# UNITED STATES PATENT AND TRADEMARK OFFICE

10/711,487

<b>Office Action Summary</b>	<b>Application No.</b>	<b>Applicant(s)</b>	
	10/711,487	JOSHI ET AL.	
	<b>Examiner</b>	<b>Art Unit</b>	
	Sunil Singh	3672

## DETAILED ACTION

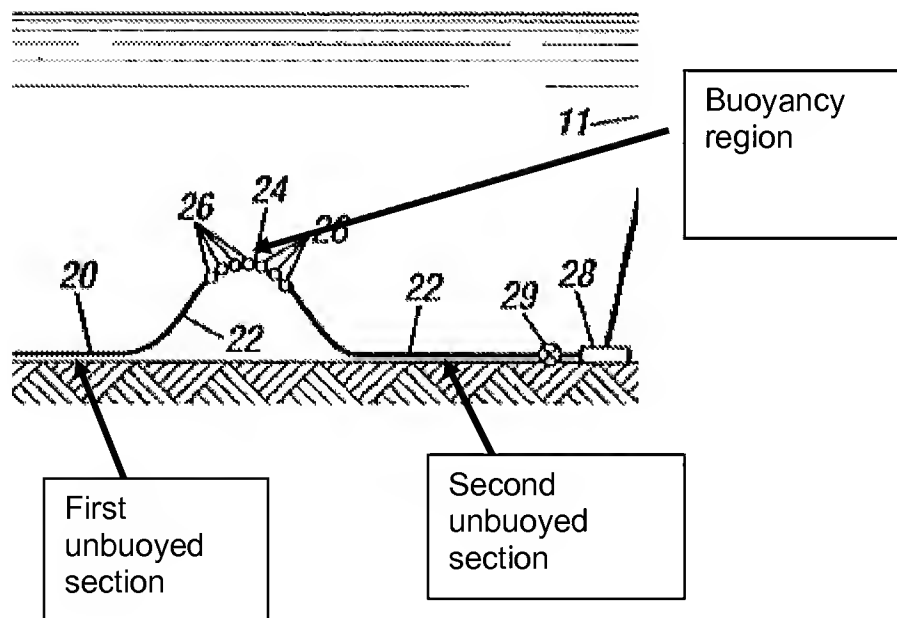
2. Claims 66-68,71,72 are rejected under 35 U.S.C. 102(b) as being anticipated by Richmond et al. (US 5582252)

Richmond et al. discloses a pipeline comprising a first unbuoyed section (see drawing below, Fig. 2), second unbuoyed section (see drawing below, Fig. 2), at least one buoyancy section (24,26) disposed between the first and second sections.
